Marvel-Schebler[®] Aircraft Carburetors, LLC

Service Bulletin: SB-15

SUBJECT – THROTTLE PLATE SCREW SECURITY

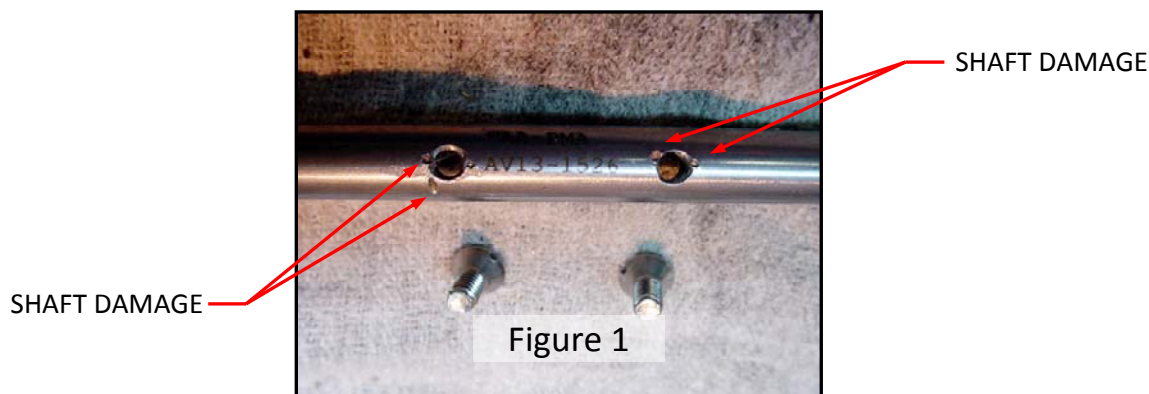
Figure 1 shows a throttle shaft and throttle valve retention screws. Staking marks can be seen in the shaft. The screws are not staked. The customer reported that the carburetor was received as part of a factory overhauled engine. It is not known if carburetors with non-staked throttle valve screws are reaching the market through other means of distribution. Figures 2 thru Figure 6 show correctly staked throttle valve retention screws. Note that the throttle shaft is not staked. The ends of the SCREWS must be upset sufficiently to prevent the screws from backing out through the shaft threads even if the screws lose torque in the shaft threads. Figure 7 shows an incorrectly staked assembly – The shaft is damaged.

- a. Visually inspect the throttle shaft and the ends of the screws to ascertain that the screws are staked in accordance with this service bulletin and that the throttle shaft has not been staked.
- b. If a staked throttle shaft or one or more non-staked throttle valve retention screws are identified, remove the carburetor from service and replace it with a serviceable carburetor.

Figure 6

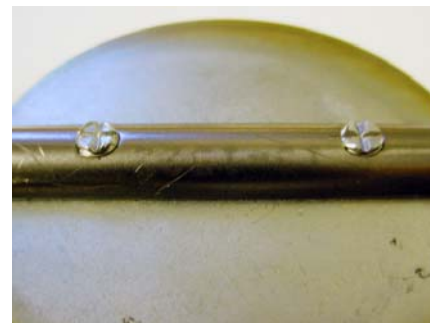
Correct Alternate Method
Only Screws Upset (No Shaft Damage)
Tool: Standard Center Punch

Figure 7

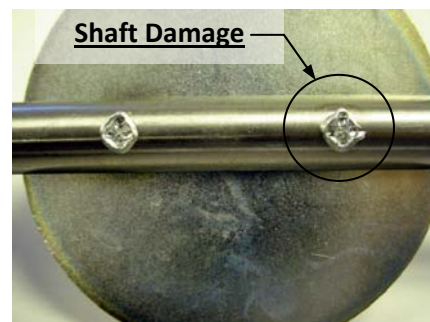
Incorrect Method
Shaft Damaged
Tool: Standard Center Punch
